STAFF REPORT
KETCHUM PLANNING AND ZONING COMMISSION
REGULAR MEETING OF JULY 13, 2021

PROJECT: The Lofts at 780

FILE NUMBER: P 21-039

APPLICATION TYPE: Preapplication Design Review

Figure 2: Elevation Showing Wall Height

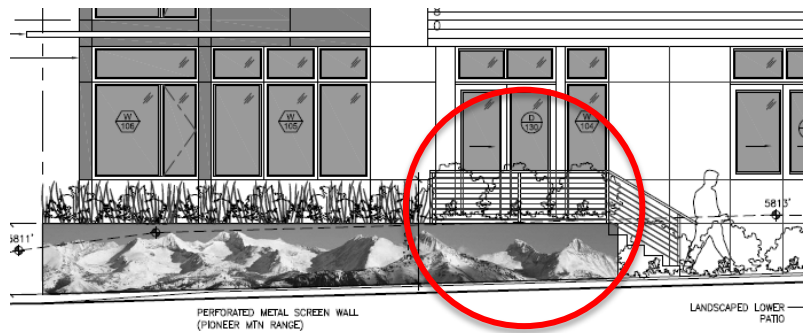
Pursuant to KMC §17.124.130 – *Fences, Walls, and Hedges*, walls within 30 feet of the front lot line may not exceed four feet in height. For the project, N 1st Ave. is the front lot line. As shown on Sheet A3.2, the mural wall that extends south from the corner of the property, tapers in height and is below four feet. However, there is an entrance to the ground floor residential unit that requires the use of stairs. When calculating the height of the wall with the stair railing, the total height is approximately 5 feet 10 inches. Although having an entrance to the unit on the ground floor

in this location is desirable from a streetscape standpoint, the code does not permit a wall and railing of this height. Staff recommends the applicant relocate the entry door to face the street and bring the stairs down to the street in front of the door. Additionally, as shown on Sheet L2, the landscaping proposed for the area along the lower patio is Peking Cotoneaster, which is a hedge like plant that has the potential to grow 5-7 feet tall in its mature state. This landscape proposal seeks to create privacy for the grade level

patio along N 1st St. A more pedestrian friendly configuration is desired. See landscape comments in the Design Review section below for staff recommendations on use of the space and plant selection for this area.

1 ARCHITECTURAL SITE PLAN - BUILDING FOOT PRINT
 A1.1 SCALE: 1" = 5'

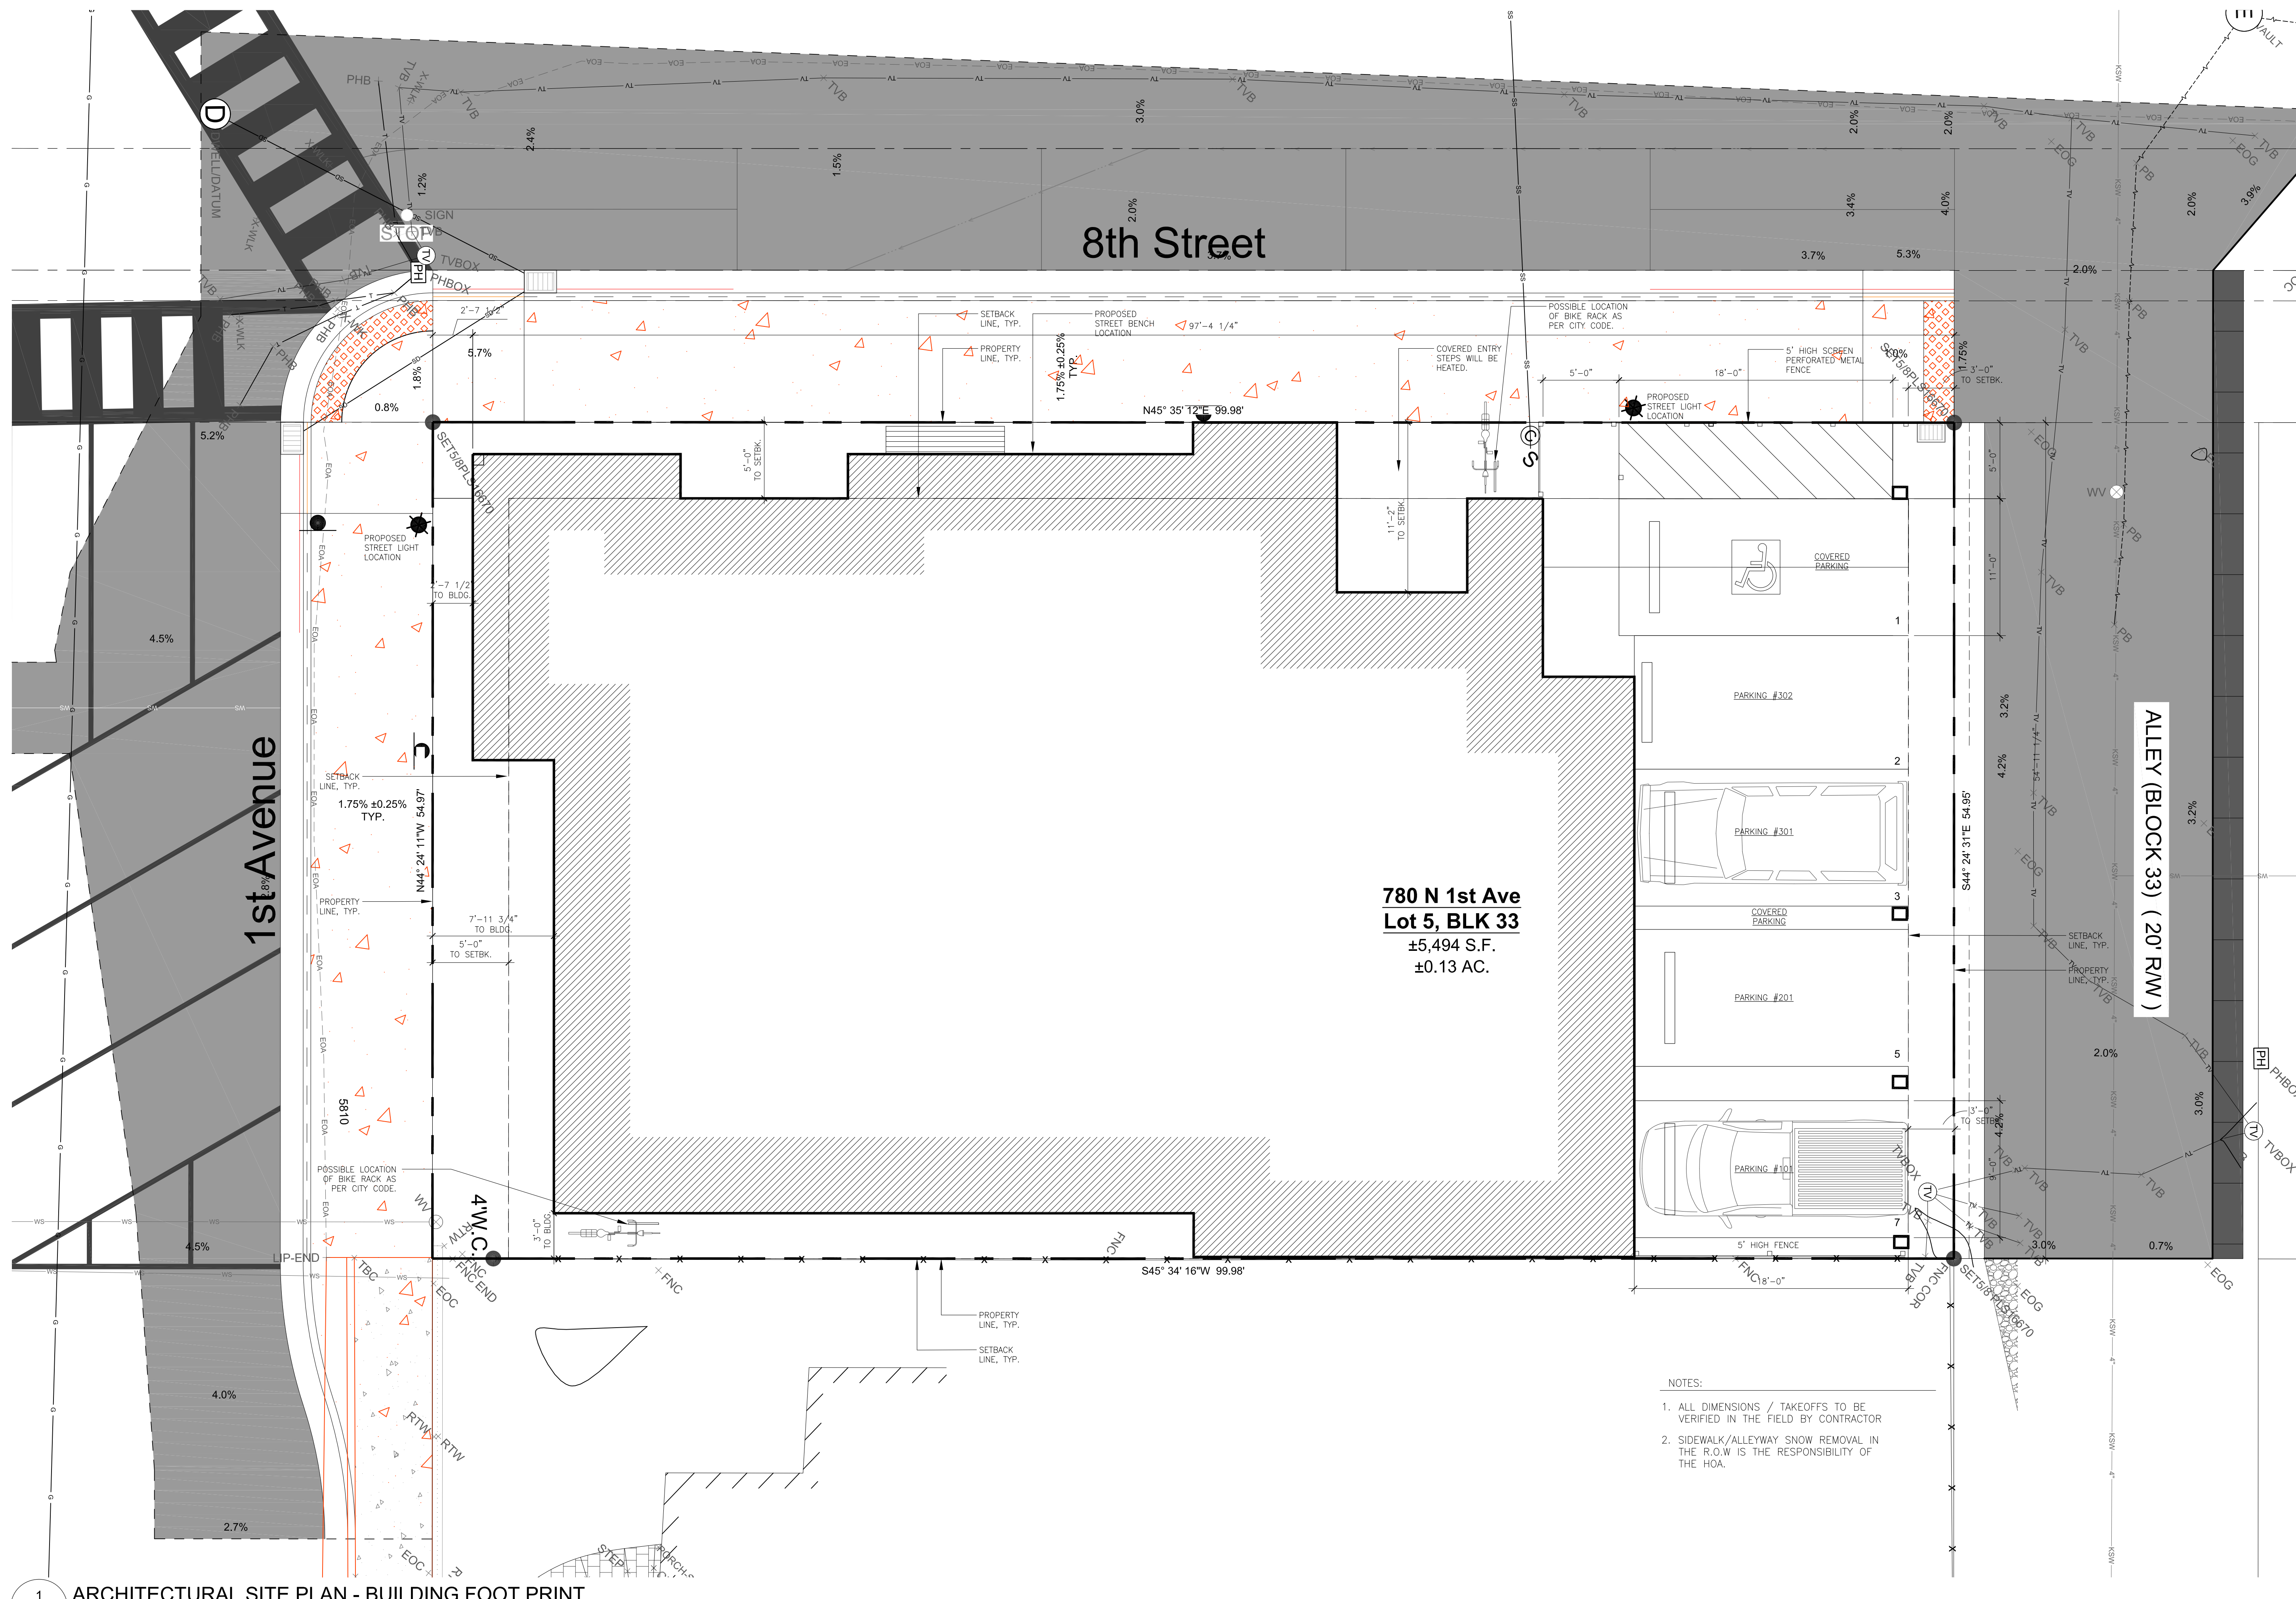
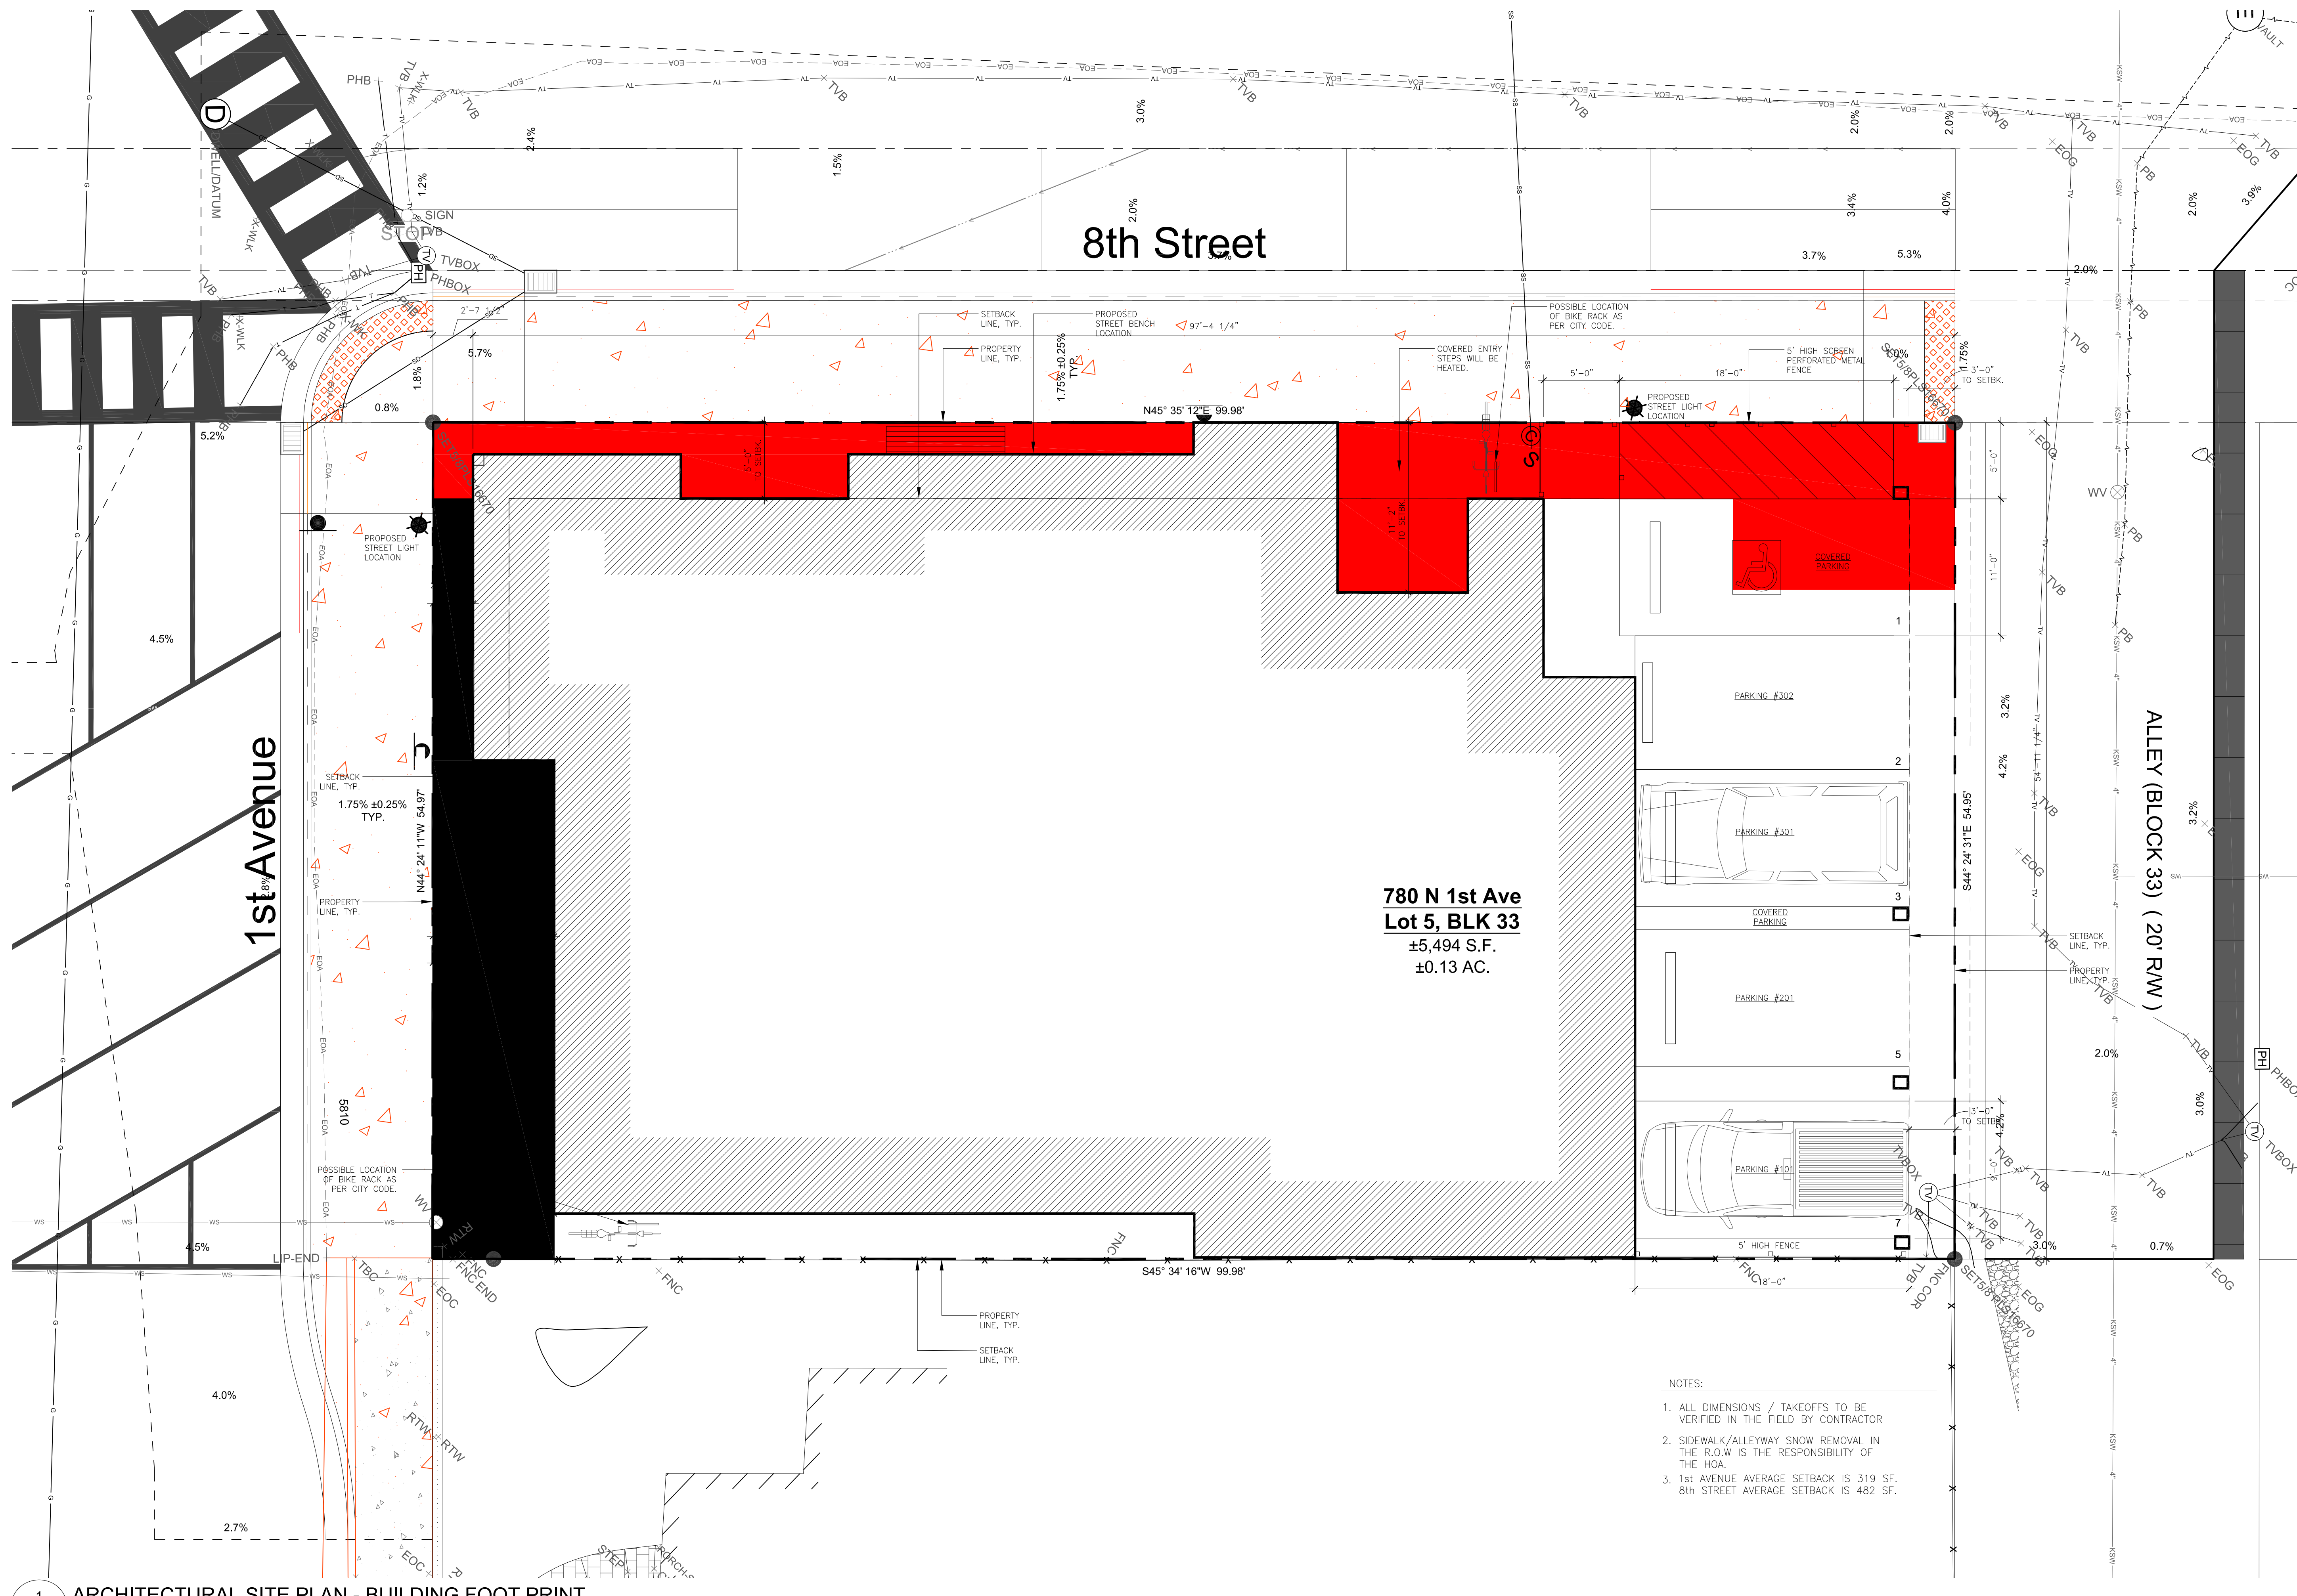
- **Setbacks** - Based on Sheet A1.1, please provide a measurement demonstrating the area of setback along both streets and outline the area included in the measurement per the interpretation below. Per Section 17.12.040.B – *Community Core Dimensional Standards*, the setback for the project must be an average of 5 feet on the front (N 1st) and an average of 5 feet on the street side (8th St). Per the attached interpretation of “Setback Average” there must be a minimum of 275 sq ft (5x55) of setback along N 1st Ave and a minimum of 475 sq ft (5x95) of setback along 8th St. Additionally, the porches identified at the ground floor are to be considered part of the building as outlined in the interpretation. If adequate setback cannot be accommodated with current design, adjustments to the design of the building must be made to conform to dimensional Standards.

- **Parking** – Based on email communication from the applicant and the revised parking shown on Sheet A1.1 dated 6/11/21, the project proposes 3 garage spaces, 4 surface parking spaces, and 1 surface accessible space. Please revised the cover letter, all site plans and floor plans to reflect the parking configuration. Per the KMC, the proposed project requires a minimum of 4 parking spaces and 1 accessible space.

The project is proposed to have an average setback along 8th street of 482 sf and then 319 sf along the primary frontage of 1st avenue. (See A1.1 B Site plan showing hatched area of setback.)

Project to provide 3 garage spaces, 4 surface parking spaces and 1 surface accessible space as per A1.1 Site plan indicates.
